TOLEDO - LUCAS COUNTY PLAN COMMISSIONS

DATE: February 10, 2023

REF: PUD-8009-22

SUBJECT: Planned Unit Development for multi-family development at 1338 N. Summit

DETAILED ELEVATIONS - BUILDING 1-6 - EAST

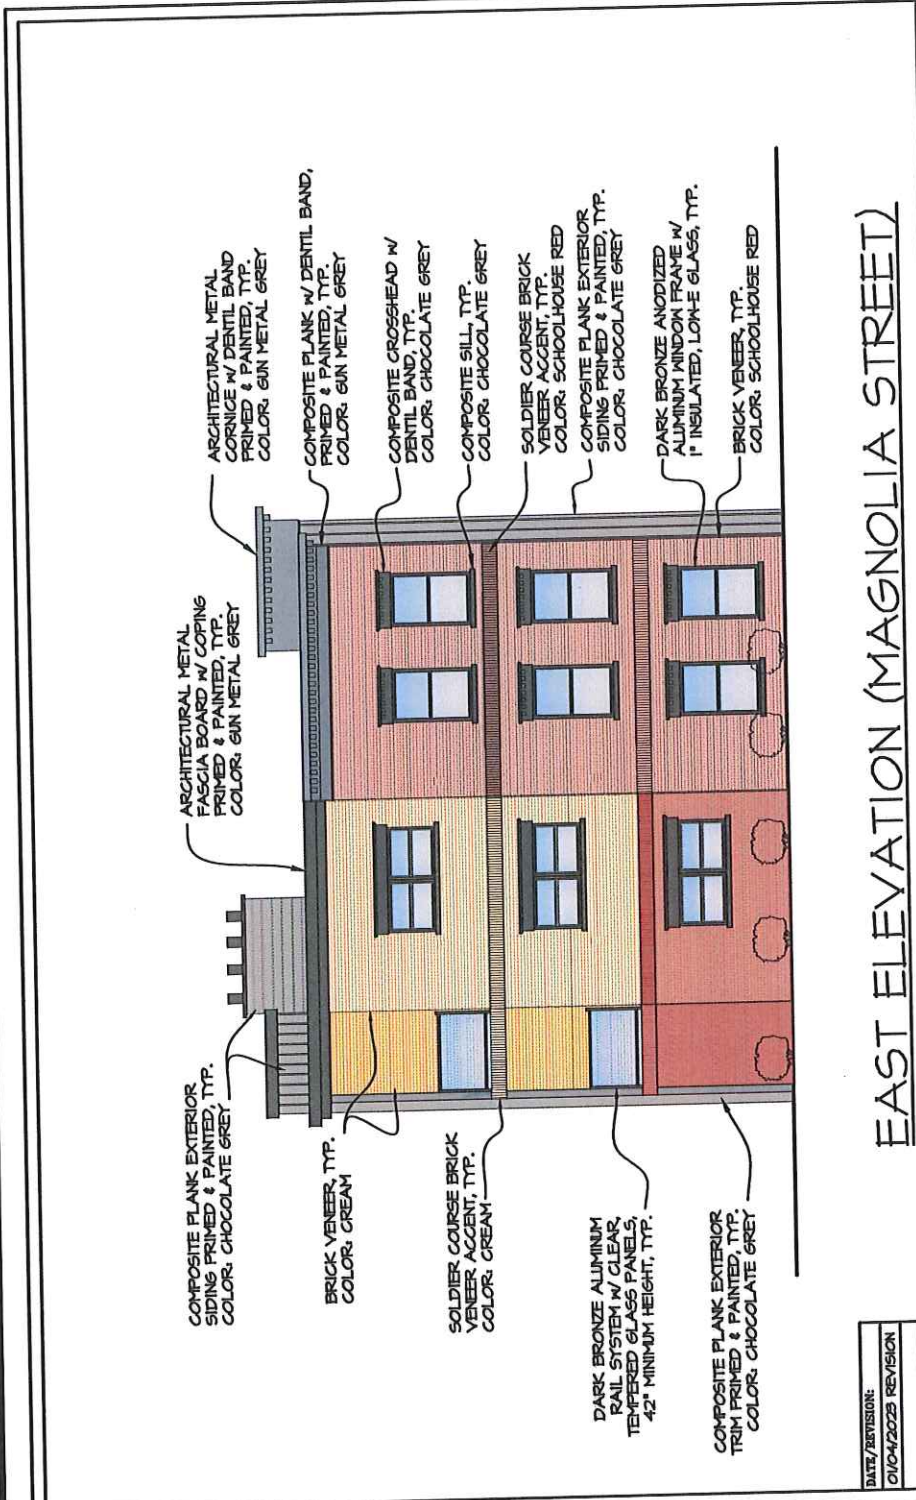
- East and West elevations depict 62% Brick, 8% Composite Plank, 13% Architectural Metal, 17% Fenestration. **Acceptable as depicted.**
 - South elevations depict 26% Brick, 22% Composite Plank, 22% Architectural Metal, 30% Fenestration. **Composite plank shall be reduced below 20% or a waiver shall be obtained.**

Approve a waiver to not require eighty percent (80%) predominant materials along the southern façade, and allow for the use of twenty-two percent (22%) composite on the southern elevation. The applicant and architect have worked with staff to create a visually appealing design which satisfactorily meets the intent of the Zoning Code.

DETAILED ELEVATIONS - BUILDING 7 & 8 - SOUTH

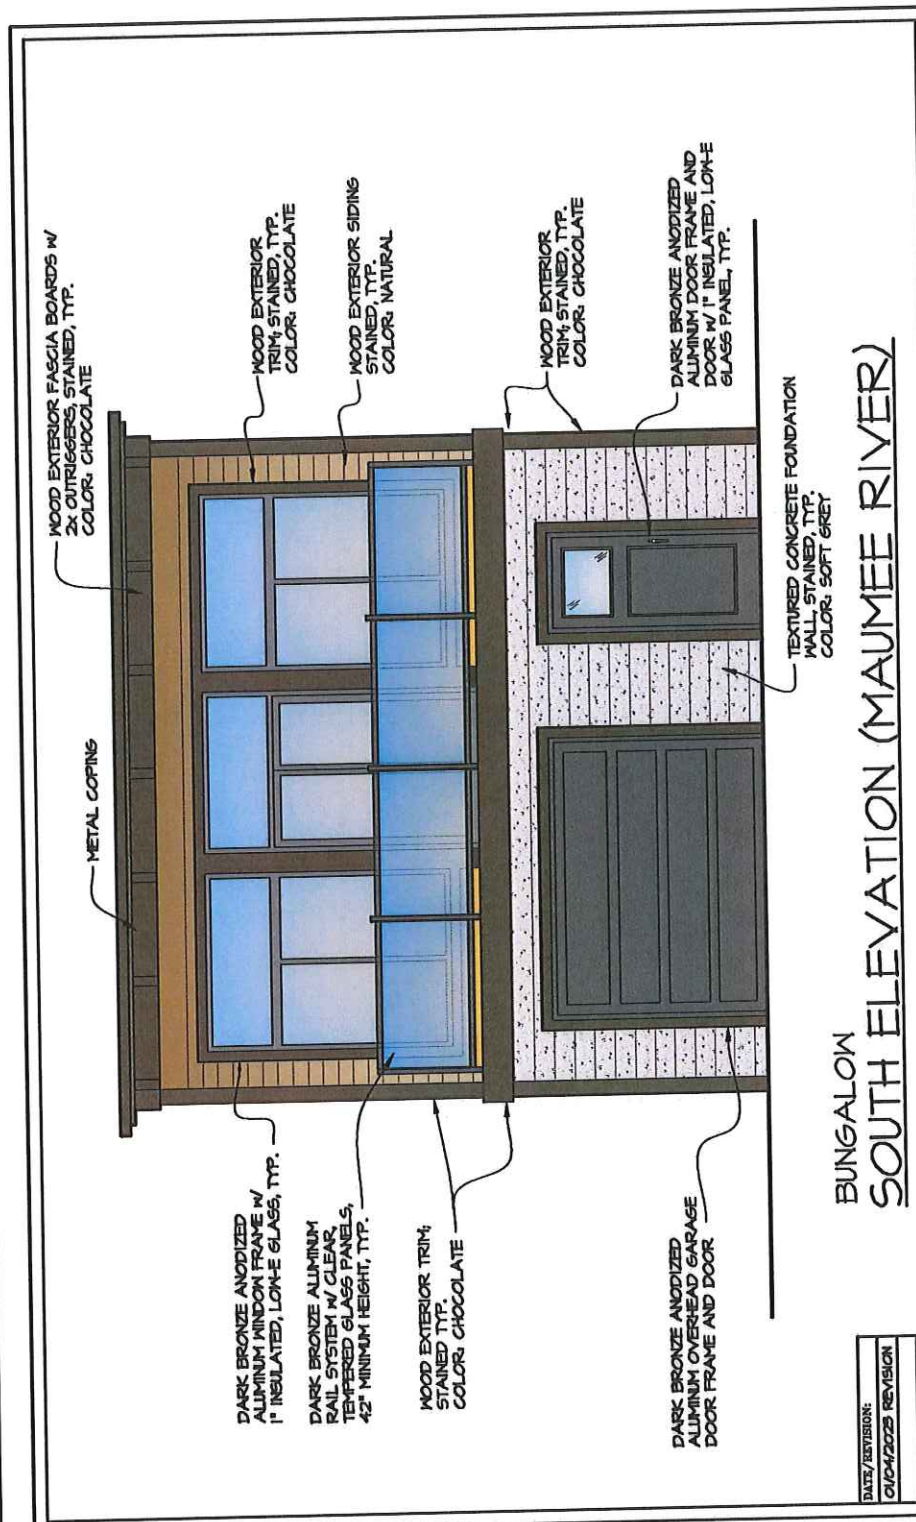
53. The elevations of buildings seven and eight (Bungalows) are subject to TMC§1109.0500 Building Façade Materials and Color. Per TMC§1109.0502(F) Wood may be permitted as a Predominant Material, subject to approval of the Director. **Samples of stained and weatherized wood shall be submitted to the Director for approval.**

DETAILED ELEVATIONS - BUILDING 7 & 8 - EAST

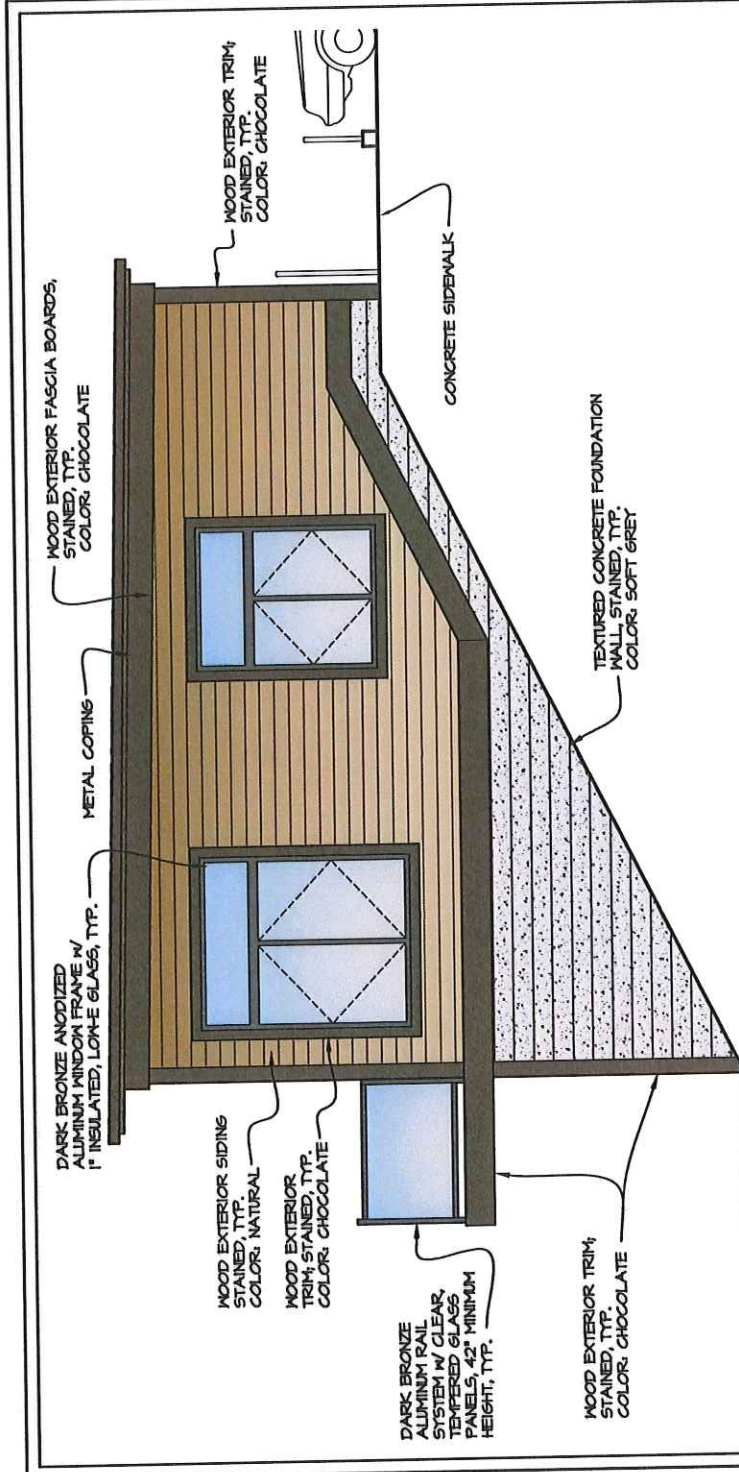
54. Units in buildings seven and eight (Bungalows) which do not have access to a 25' drive aisle shall not be permitted to include a garage door. **Shall be depicted on revised elevations.**
